## Submission for Collector, Modification 1

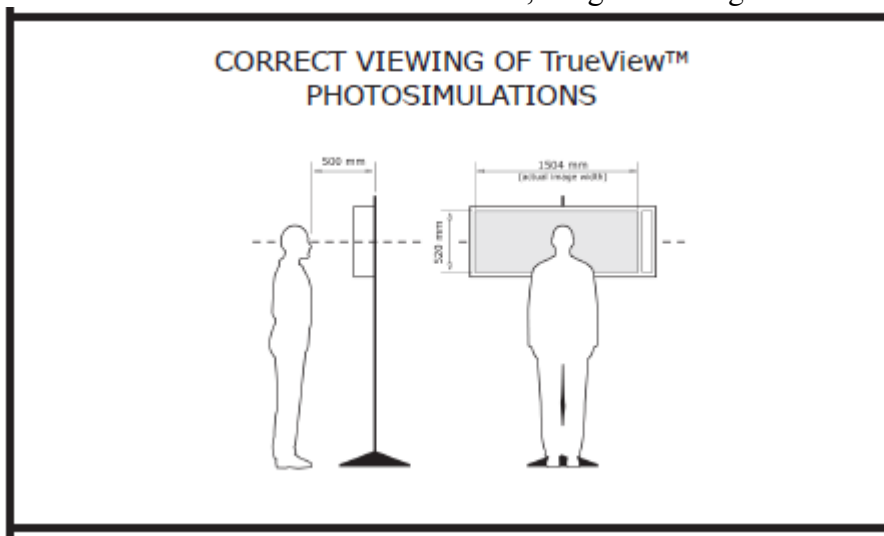
I also congratulate Truescape Australia for the detail in their photomontages, even down to the time the photograph was taken. The best bit of course was the small diagram on each one showing how their photomontages should be viewed. Instead of some fine print about “these are best viewed at A0 scale”, we get this diagram:

The dimensions of the suggested photomontage are 1504mm x 520mm. (on that scale, by the way, the viewer is 2.19 metres or 7 ft 2 inches for us oldies – we’d love him at the Swans)

Does the Department not realise how ludicrous this is. This is larger than A0. Truescape advise us on every photomontage:

The answer is simple and well known to the Department: include in the published EIS, the A4 section right in front of the viewers nose. Truescape knows this as well, as one of the photomontages, VP02\_Full TrueView\_Zoomed Portion Overlay, shows this concept, See further for the resulting photo.
